# UNITED STATES PATENT AND TRADEMARK OFFICE

APPLICATION NO.	FILING DATE	FIRST NAMED INVENTOR	ATTORNEY DOCKET NO.	CONFIRMATION NO.
09/605,227	06/28/2000	Yutaka Kuba	81870.0009	6219
26021	7590	05/03/2004	EXAMINER	
HOGAN & HARTSON L.L.P. 500 S. GRAND AVENUE SUITE 1900 LOS ANGELES, CA 90071-2611			PAK, SUNG H	
			ART UNIT	PAPER NUMBER
			2874

<b>Office Action Summary</b>	<b>Application No.</b> 09/605,227	<b>Applicant(s)</b> KUBA, YUTAKA	
	<b>Examiner</b> Sung H. Pak	<b>Art Unit</b> 2874

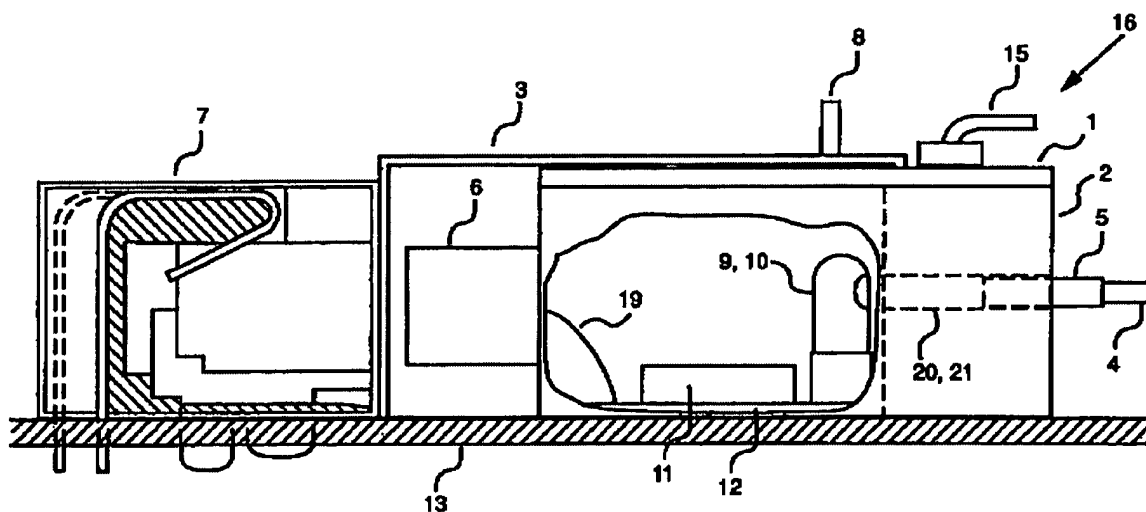
Claims 18, 24, 26-27 are rejected under 35 U.S.C. 102(b) as being anticipated by Beckwith (US 5,615,292).

Beckwith reference discloses an optical device with all the limitations set forth in the claims, including: an optical module comprising a package casing provided with an electric terminal ('6') on a surface thereof (column 2 lines 49-50), the package casing having a mount space (area occupied by '12'); a substrate('12') bearing an optical element ('9,10'); an electrode drawn from the optical element (not shown in the figure below, but an electrode is inherently taught in the circuit board '12'); one end of a slender light transmitter (optical fiber '4'); the

optical element and the one end of the light transmitter being fixedly attached on the substrate and optically coupled with each other (figure below); the substrate being placed in the mount space of the package casing (figure below); a bonding member ('19') which connects the electric terminal of the package casing (provided on '6') and the electrode pad on the substrate, the electric terminal being adapted to be electrically connected with an external circuit ('13') through a connector ('6,7') (See figure below and figures 1-2 of Beckwith).

Regarding claim 24, Beckwith also discloses: a connector ('7') including a receptacle (Figure below), a module connection terminal (figure below- curve shaped portion of the electrical terminal) and a circuit board connection terminal (electrical terminal portion that connects to element '13') electrically connected with the module connection terminal ('6') and connectable with an electric circuit board; wherein the reception space is opened to the electric circuit board ('13'); wherein the module connection terminal provided in the connector has the form of a spring (curved portion of the electrical terminal in '7') and exposed to the receptacle.
